**Re: Architectural Review 21-10 (Administrative)
Proposed Solar Farm on the northeast portion of an existing development
(Woodspur Farms facility)
52200 Industrial Way, Coachella CA 92236**

Planning Case Conditions

City Case Number: AR 21-10

Project Name: Woodspur Farms PV Project

SITE PLAN

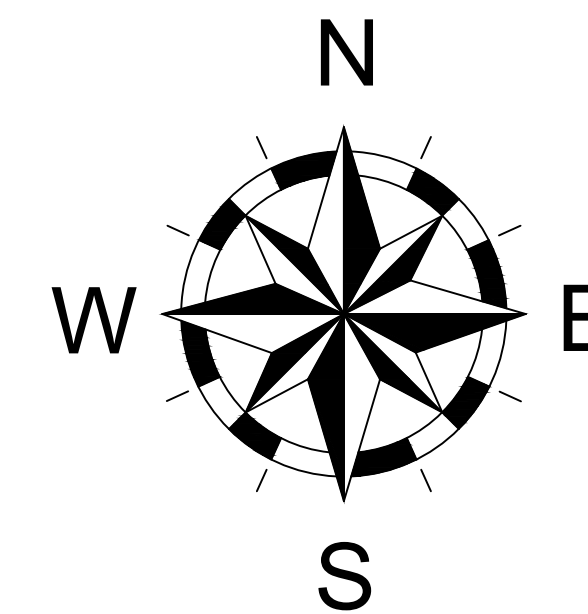
2. Show the fire apparatus access road on the site plan. The fire access road shall extend to within 300 feet of all portions of the facility - as measured from the access road to all portions of the facility on an approved walkway through and between the length of solar arrays. The access road shall be a minimum width of 20 feet, have a minimum outside turning radius of 38 feet, and be capable of supporting the load of fire apparatus (50,000 lbs.) under all weather conditions. Access gate openings for vehicles shall be a minimum of 14 feet wide and 4 feet wide for pedestrian access.

3. Dead-end fire apparatus access roads in excess of 150 feet in length shall be provided with an approved area for turning around fire apparatus. Turning areas shall be designed in accordance with Riverside County Fire Department standards.
